NOTICE OF FINAL PUNCH LIST AND DEFECTIVE ITEMS

Project Name: SW 2nd Avenue Median Parking

Project #: 12381

FINAL SITE INSPECTION REPORT

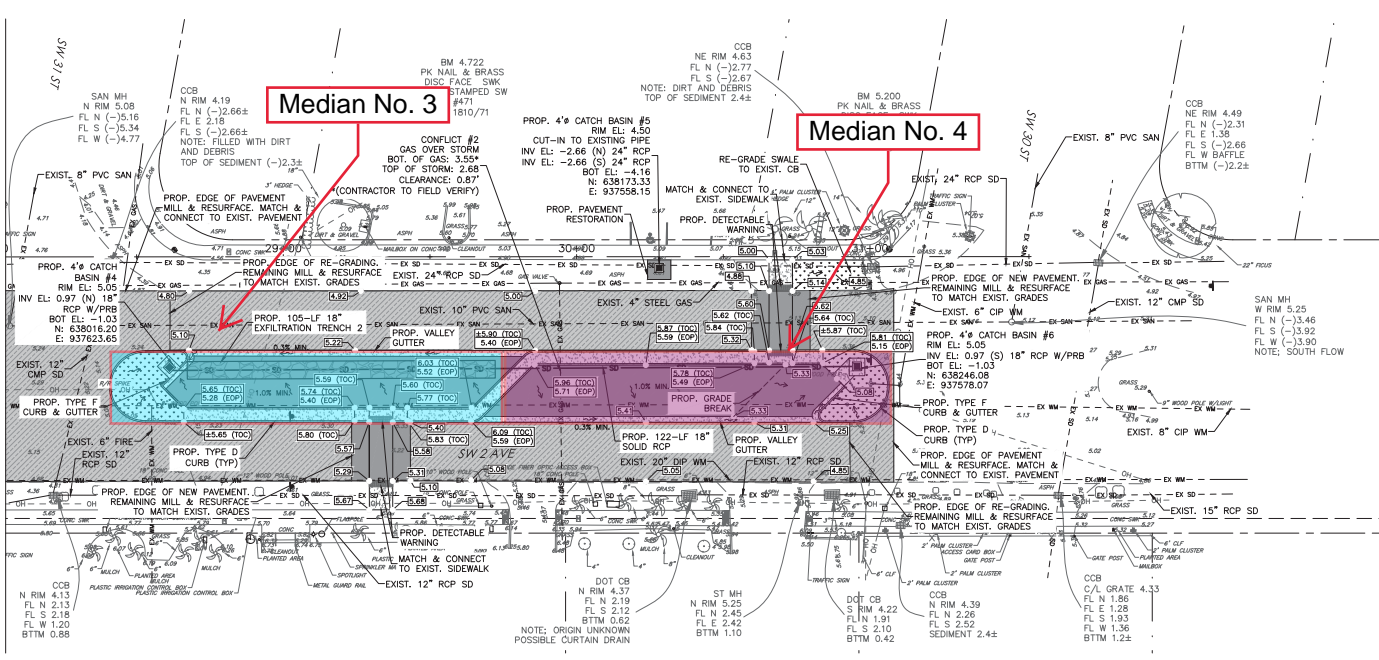
- a. Crack(s) recorded at Concrete Sidewalk STA 25+64 (4th joint North of ADA detectable warning surface).
- b. Crack(s) recorded at Concrete Sidewalk STA 25+69 (5th joint North of ADA detectable warning surface).

- c. Grinding of concrete at Valley Gutter STA 26+26 (North of catch basin No. 1 inlet).
- d. Crack(s) recorded at Valley Gutter STA 26+19 (South of catch basin No. 1 inlet).

- e. Deficient Valley Gutter Concrete/Asphalt interface STA 25+92 (3rd joint South of inlet of catch basin No. 1).
- f. Crack(s) recorded at Valley Gutter STA 25+39 (1st joint from South to North).

- g. Crack(s) recorded at Valley Gutter STA 25+49 (2nd joint from South to North).
- h. Joint missing and crack(s) recorded at Valley Gutter STA 25+30 (convergence of Valley Gutter and Type F Curb).

- i. Incorrect jointing pattern recorded on Concrete Sidewalk STA 25+25 to 26+33 (entire median).
- j. Ponding recorded on Concrete Sidewalk flags No. 1, No. 4, and No. 9 from North to South (STA 26+10, STA 25+95, and STA 25+35 respectively).

- k. Crack(s) recorded on curved portion of Type D Curb STA 25+05.

Median No. 1 (STA 25+05 – STA 26+30)

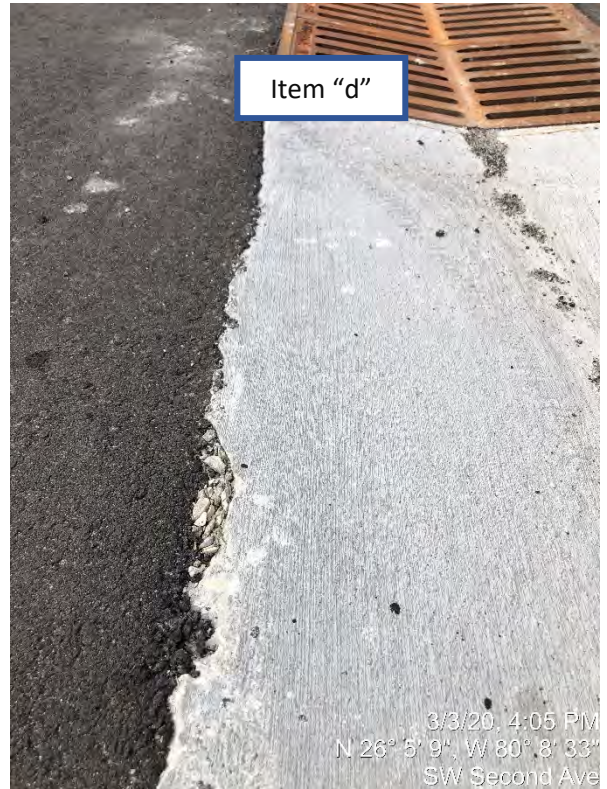
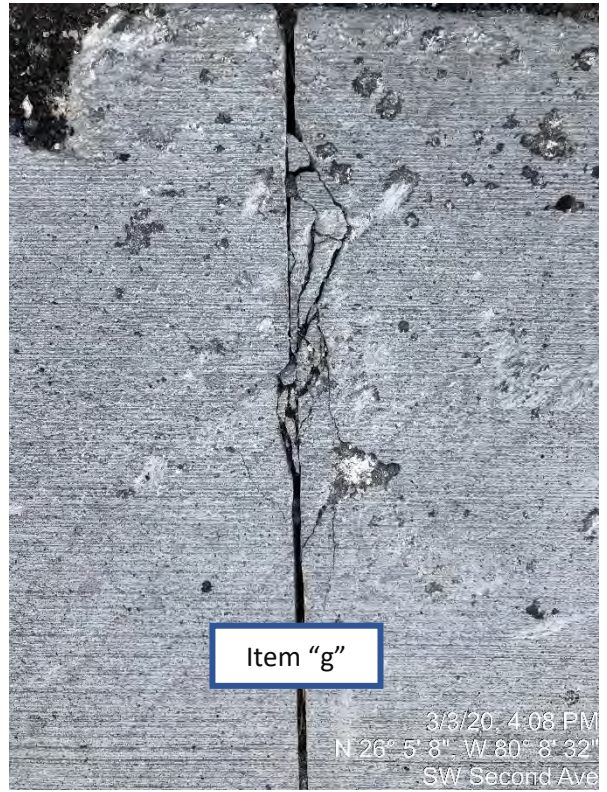
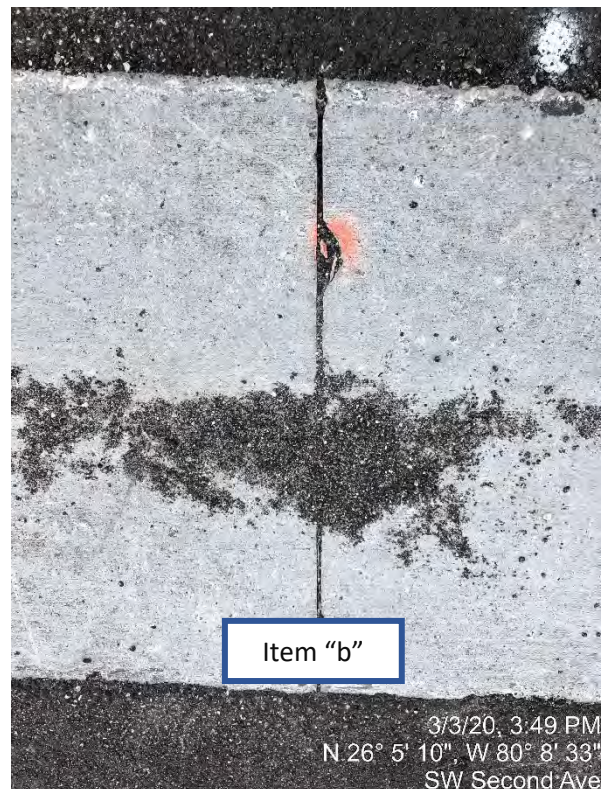
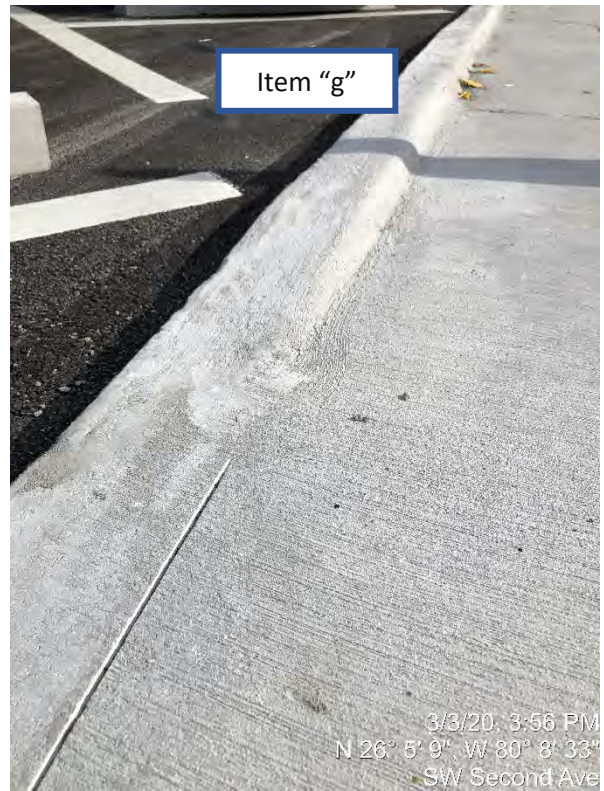
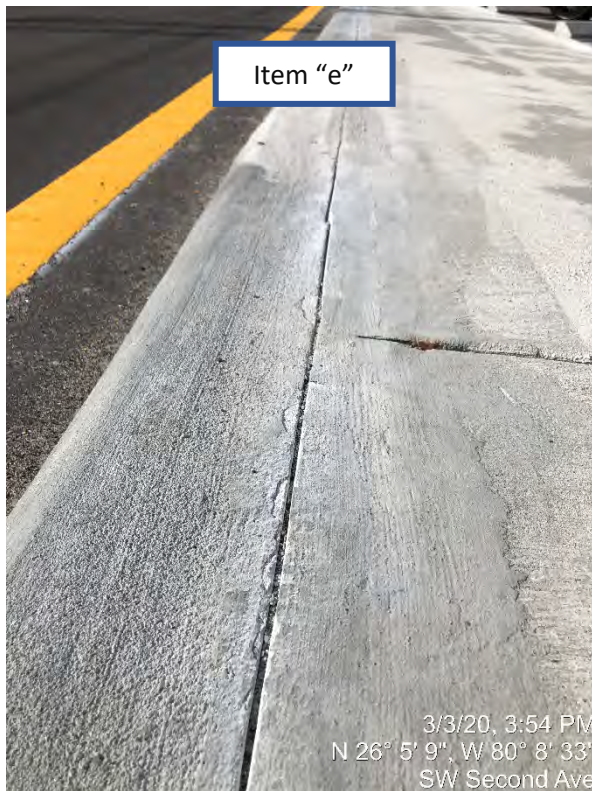
02772 – Asphalt Concrete Pavement

- a. Oil stains recorded on parking spaces No. 1, No. 2, and No. 8 from North to South STA 26+00 to STA 26+30, and STA 25+40.
- b. Ponding recorded on parking spaces No. 1, No. 2, No. 3, No. 4, and No. 8 from North to South (STA 26+25 to STA 25+85, and STA 25+30 respectively).
- c. CONTRACTOR failed to test for conformity with the specified grade after initial compression. Variance in surface more than 1/8-inch from the lower edge of a 12-foot straightedge recorded on parking space No. 8 from North to South STA 25+30.

Median No. 2 (STA 26+15 – STA 27+65)

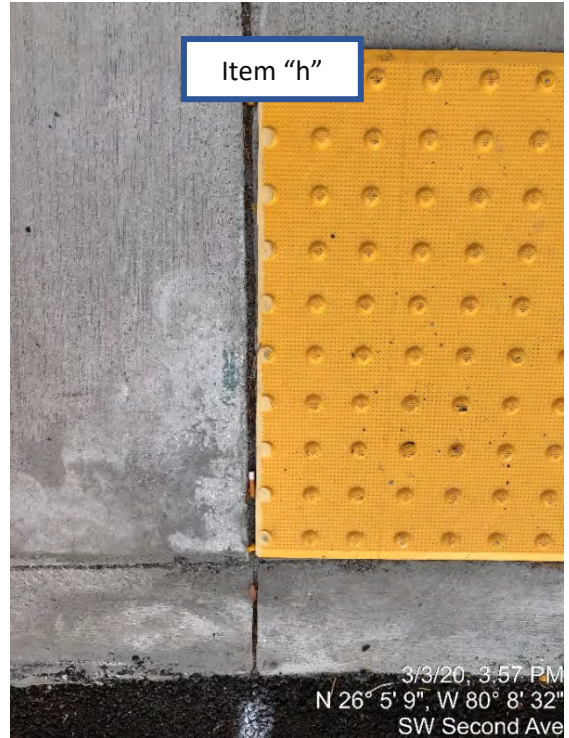
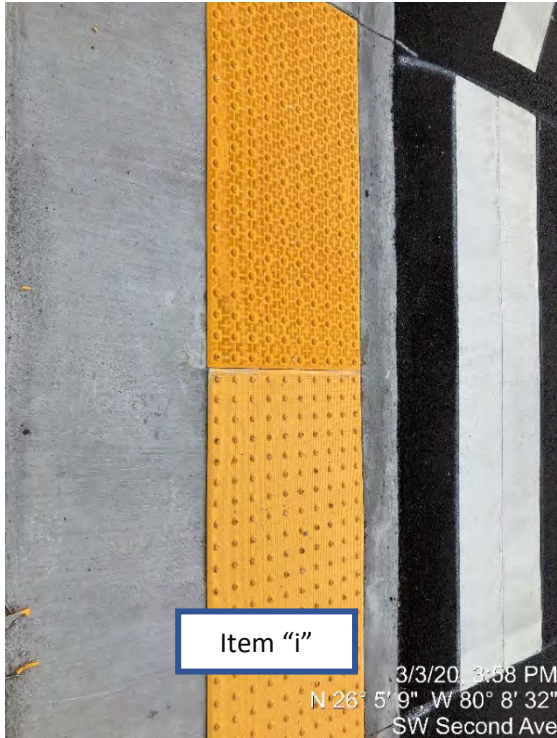
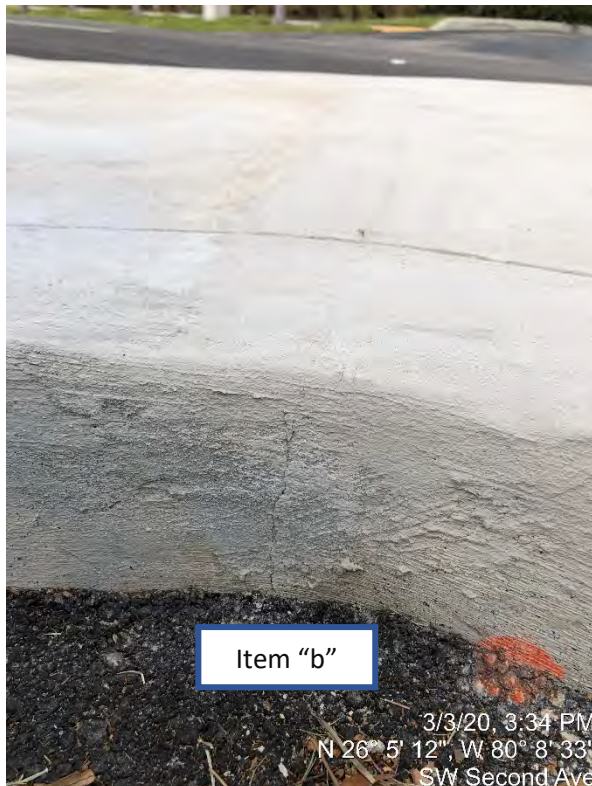
- a. Grinding of concrete at Valley Gutter STA 27+40 (convergence of Valley Gutter and Type F Curb).
- b. Crack(s) recorded at Valley Gutter STA 27+30 (1st joint from North to South).

- c. Concrete Wheel Stop damaged STA 26+49 (2nd from South to North).
- d. Concrete Wheel Stop inadequately installed 27+45 (1st from North to South).
- e. Repair method was not reviewed/approved by the City and it shows poor finish on Type D Curb STA 26+33 to STA 27+43. (deficiencies recorded at both sides of Concrete Sidewalk).

- f. Incorrect jointing pattern recorded on Concrete Sidewalk STA 26+33 to STA 27+43 (entire median).
- g. Expansion joint between Concrete Sidewalk and Type D Curb is interrupted at ADA accessible route ramp STA 26+62.

- h. Concrete grinding and/or poor finish on Concrete Sidewalk STA 26+67. (North and against detectable warning surface).
- i. Mismatch of detectable warning surfaces recorded STA 26+62.

- j. Ponding recorded on Valley Gutter STA 27+40 to STA 27+10. Low elevation grade at North end of Valley Gutter.
- k. Ponding recorded on Concrete Sidewalk flags No. 2, No. 3, and No. 5 from North to South (STA 27+35 to STA 27+25, and STA 27+15 respectively).

- l. Ponding recorded on Concrete Sidewalk behind detectable warning surface STA 26+63.
- m. Trip hazard between Type D Curb and Concrete Sidewalk STA 26+62.

- a. Ponding recorded behind Wheel Stops of parking spaces No. 2 and No. 8 from North to South STA 27+31 and STA 26+54 respectively.
- b. Ponding recorded on parking spaces No. 1 and No. 10 from North to South STA 27+39 and 26+33 respectively.

Median No. 3 (STA 28+40 – STA 29+85)

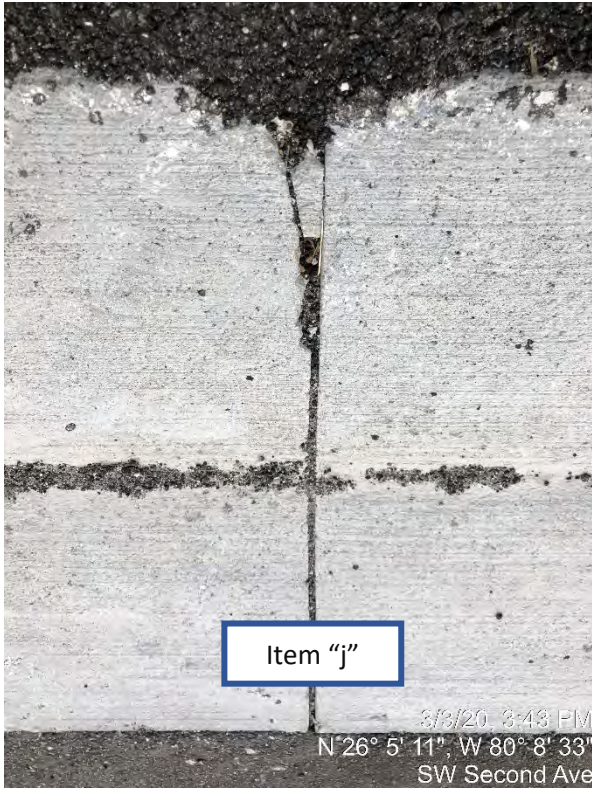
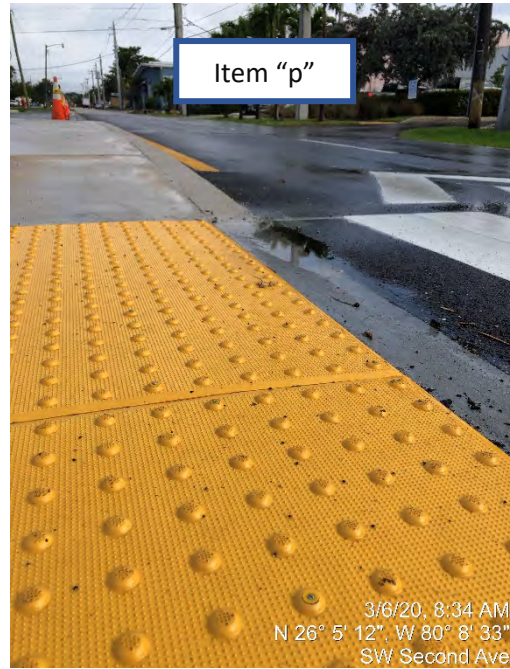
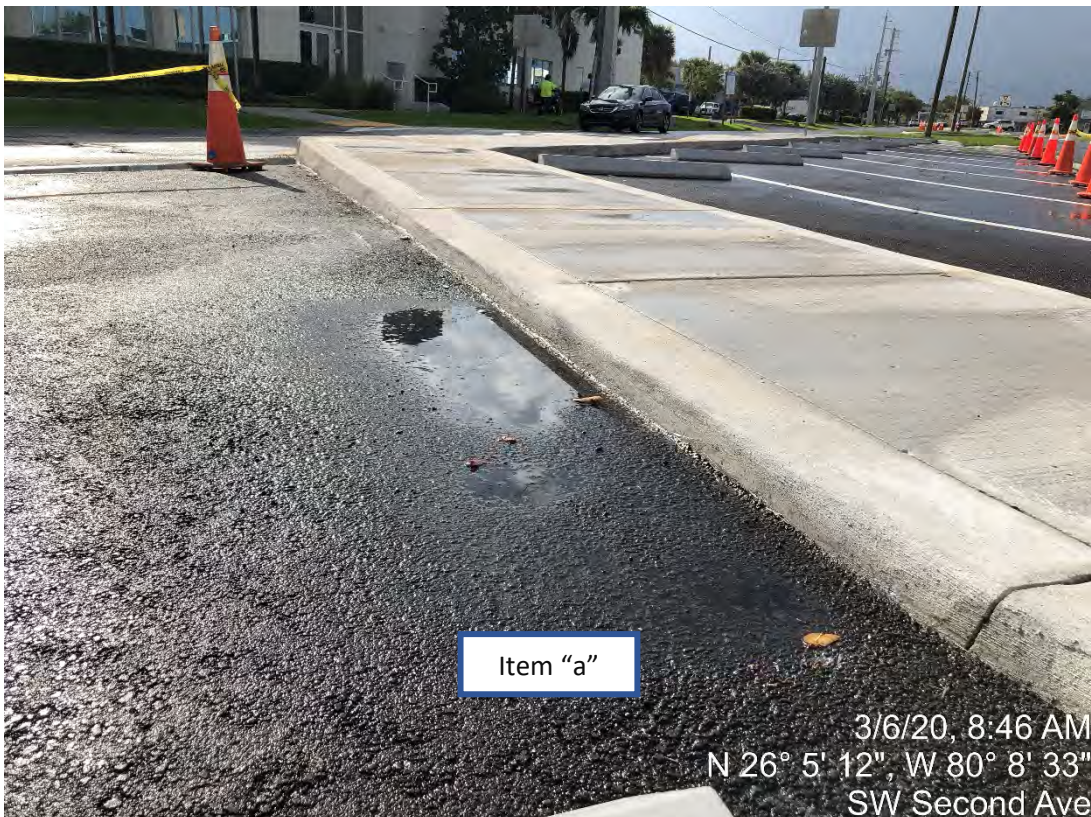
- a. Crack(s) recorded at Valley Gutter STA 29+82 (convergence of Valley Gutter and Type F Curb).
- b. Repair method was not reviewed/approved by the City and it shows poor finish on Type D Curb STA 29+66 to STA 29+85.

- c. Crack(s) repair method was not reviewed/approved by the City and it shows poor finish on Concrete Sidewalk STA 29+66.
- d. Repair method was not reviewed/approved by the City and it shows poor finish on Concrete Sidewalk STA 26+05 to STA 28+65.

- e. Expansion joint between Concrete Sidewalk and Type D Curb is interrupted at ADA accessible route ramp STA 29+31.
- f. Crack(s) repair method was not reviewed/approved by the City and it shows poor finish on Concrete Sidewalk STA 29+24 to STA 29+42 (ADA accessible route ramps and landing).

- g. Crack(s) recorded at Type F Curb STA 28+45 (two locations on the curved portion of the curb).
- h. Grinding of concrete recorded at catch basin No. 4 pad STA 28+62.

- i. Crack(s) and grinding recorded at Valley Gutter STA 28+76 (1st joint from South to North).
- j. Crack(s) recorded at Valley Gutter STA 28+85 (2nd joint from South to North).

- k. Incorrect jointing pattern recorded on Concrete Sidewalk STA 28+65 to STA 29+85 (entire median).
- l. Crack(s) recorded at Valley Gutter STA 29+82 (1st joint from North to South).

- m. Trip hazard between Type D Curb and Concrete Sidewalk STA 29+50.
- n. Expansion joints on curved portion of Type D Curb are irregular and not beveled.

- o. Ponding recorded throughout the Valley Gutter STA 28+67 to STA 29+54 and at STA 29+84 (North end). Low elevation grade recorded at both ends of Valley Gutter.

- p. Ponding recorded on Concrete Sidewalk behind detectable warning surface STA 29+34, and at flags No. 12 and No. 13 South of ADA accessible route ramp (STA 28+67 to STA 28+77).

- a. Ponding recorded on Concrete Sidewalk between medians III and IV (STA 29+65 to STA 29+84)
- b. Oil stains recorded on parking spaces No. 3, No. 6, and No. 7 from North to South (STA 29+43, STA 29+95, and STA 29+12 respectively).
- c. Ponding recorded on parking spaces No. 5, No. 6, No. 8, and No. 9 (STA 29+05 to STA 29+30, and STA 28+60 to STA 28+90).
- d. CONTRACTOR failed to test for conformity with the specified grade after initial compression. Variance in surface more than 1/8-inch from the lower edge of a 12-foot straightedge recorded on parking spaces No. 2, No. 6, and No. 8 from North to South STA 29+67, STA 29+06, and STA 28+88.

Median No. 4 (STA 29+64 – STA 31+08)

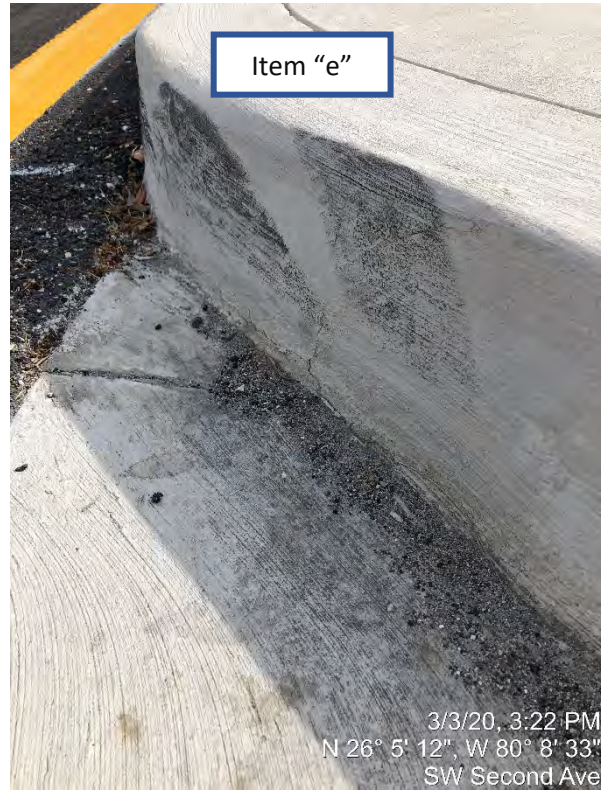
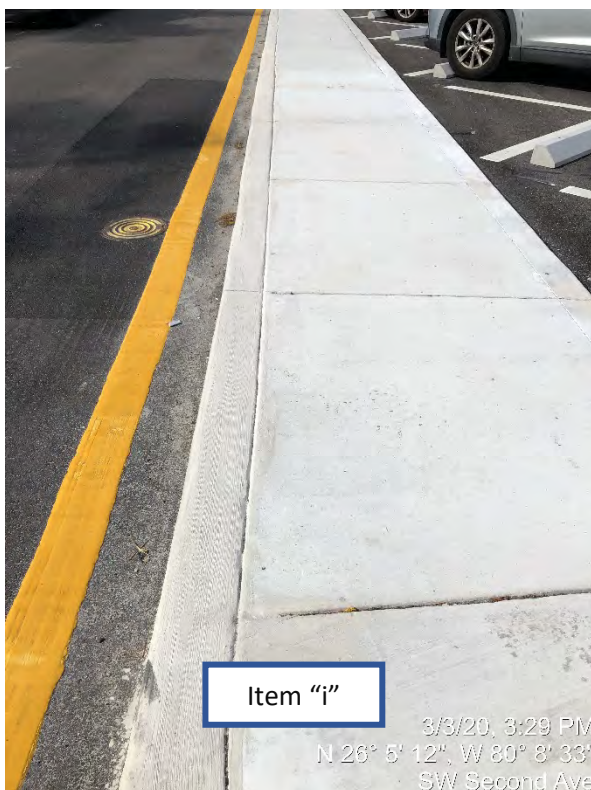
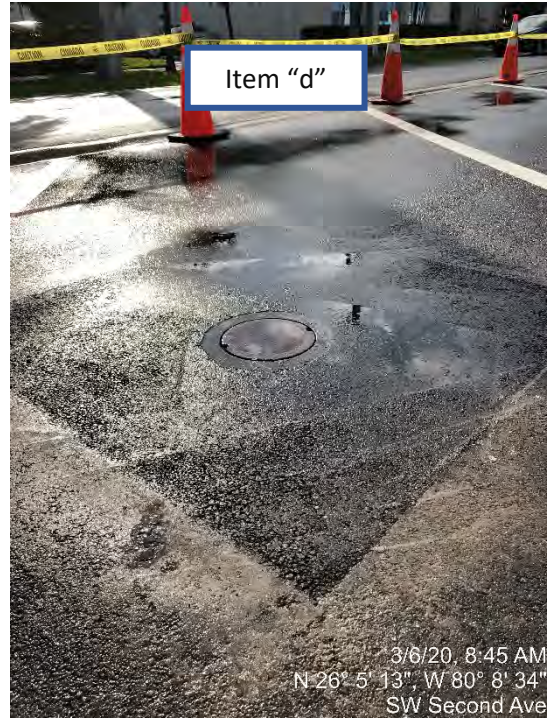
- a. Expansion joints on curved portion of Type D Curb are not beveled.
- b. Crack(s) recorded at Type D Curb STA 30+94 (West side of curb).
- c. Crack(s) and low elevation grade recorded on Type F Curb STA 30+83 (convergence of Valley Gutter and Type F Curb).

- d. Grinding of concrete at Valley Gutter STA 30+29 and STA 30+66
- e. Crack(s) and low elevation grade recorded at Valley Gutter STA 29+67 (beginning of Valley Gutter).

- f. Grinding of concrete at Sidewalk STA 30+82 (1st flag from North to South)
- g. Incorrect jointing pattern recorded on Concrete Sidewalk STA 29+85 to STA 30+85 (entire median).

- h. Crack(s) repair method was not reviewed/approved by the City and it shows poor finish on Type D Curb STA 29+85 to STA 30+65.
- i. Crack(s) repair method was not reviewed/approved by the City and it shows poor finish on Concrete Sidewalk and Type D Curb STA 29+88 (1st joint from South to North).

- j. Ponding recorded throughout the Valley Gutter STA 29+66 to STA 30+83. Low elevation grade recorded at both ends of Valley Gutter.
- k. Ponding recorded on Concrete Sidewalk behind detectable warning surface STA 30+71, and at flags No. 2, No. 7, No. 9, and No. 12 South of ADA accessible route ramp (STA 30+56, STA 30+24, 30+15, and STA 30+00 respectively).

- l. Trip hazard between Type D Curb and Concrete Sidewalk STA 30+71.

- a. Ponding recorded behind Wheel Stops of parking spaces No. 2 and No. 3 from North to South STA 30+58 to STA 30+76.
- b. Ponding recorded behind Wheel Stops of parking spaces No. 5 and No. 6 from North to South STA 30+22 to STA 30+45.
- c. Ponding recorded on SW 2nd Avenue Southbound lane STA 30+85.
- d. Ponding recorded on parking space No. 5 from North to South due to irregular asphalt patch surrounding gas valve STA 30+31.
- e. Ponding recorded on parking space No. 9 from North to South against Type D Curb STA 29+76.
- f. CONTRACTOR failed to test for conformity with the specified grade after initial compression. Variance in surface more than 1/8-inch from the lower edge of a 12-foot straightedge recorded on parking space No. 2 from North to South STA 30+68.
